Re: **Docket No. 477 – Application Of Cellco Partnership d/b/a Verizon Wireless For A Certificate Of Environmental Compatibility And Public Need For The Construction, Maintenance And Operation Of A Wireless Telecommunications Facility At 46 Cemetery Road, Canterbury, Connecticut**

IN RE: :
 :
APPLICATION OF CELLCO PARTNERSHIP : DOCKET NO. 477
D/B/A VERIZON WIRELESS FOR A :
CERTIFICATE OF ENVIRONMENTAL :
COMPATIBILITY AND PUBLIC NEED FOR :
THE CONSTRUCTION, MAINTENANCE :
AND OPERATION OF A WIRELESS :
TELECOMMUNICATIONS FACILITY AT 46 :
CEMETERY ROAD IN CANTERBURY, :
CONNECTICUT : NOVEMBER 17, 2017

**RESPONSES OF CELLCO PARTNERSHIP D/B/A VERIZON WIRELESS
TO CONNECTICUT SITING COUNCIL PRE-HEARING INTERROGATORIES**

DRAWING TITLE:
**COMPOUND PLAN,
NORTH ELEVATION
& ANTENNA PLAN**

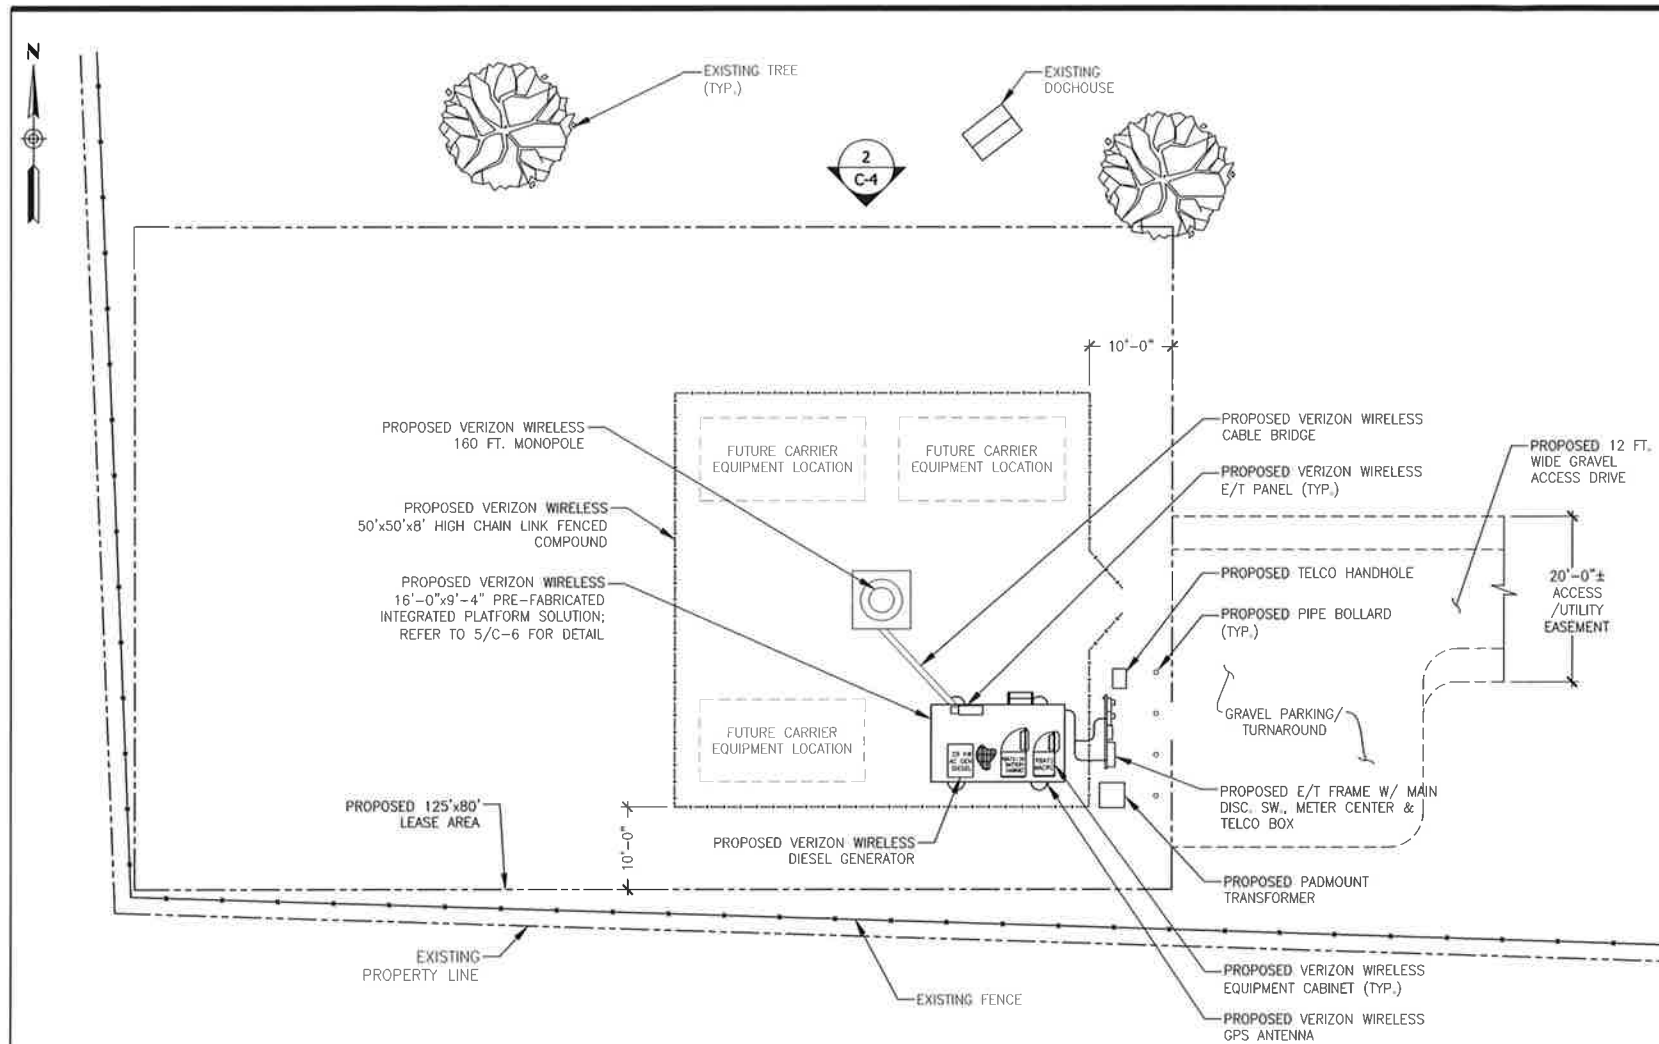
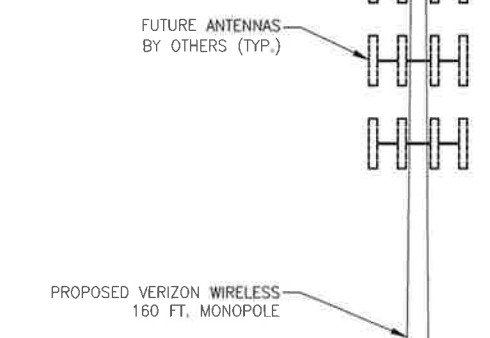
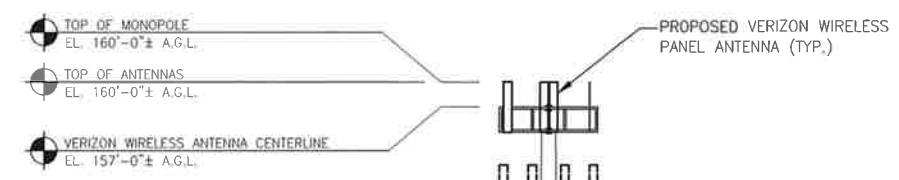
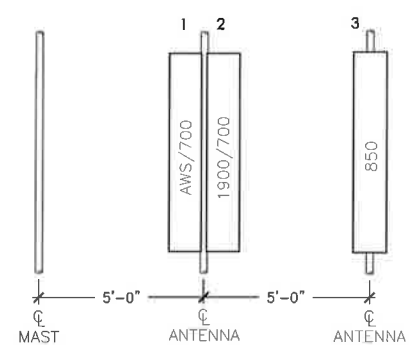
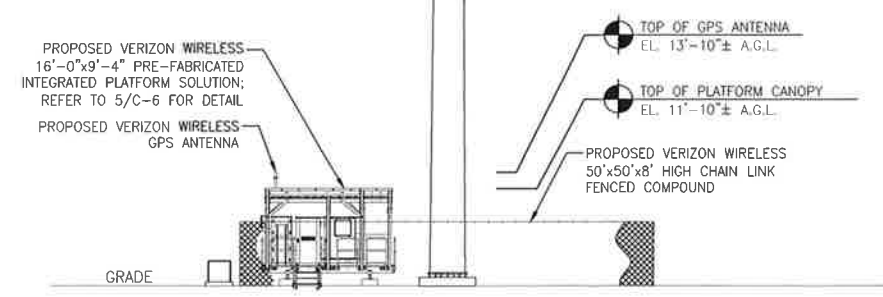
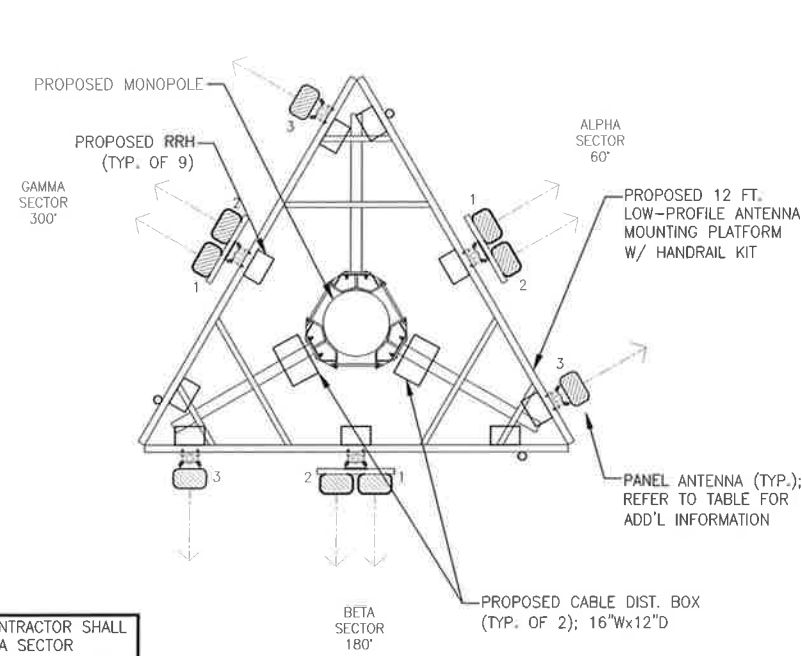
Submit tower profile/compound layout drawings that depict Cellco's proposed antenna installation, locations for potential tower/compound sharing by other carriers, and a tower yield point location.

The compound layout drawing requested is included in Attachment 1.
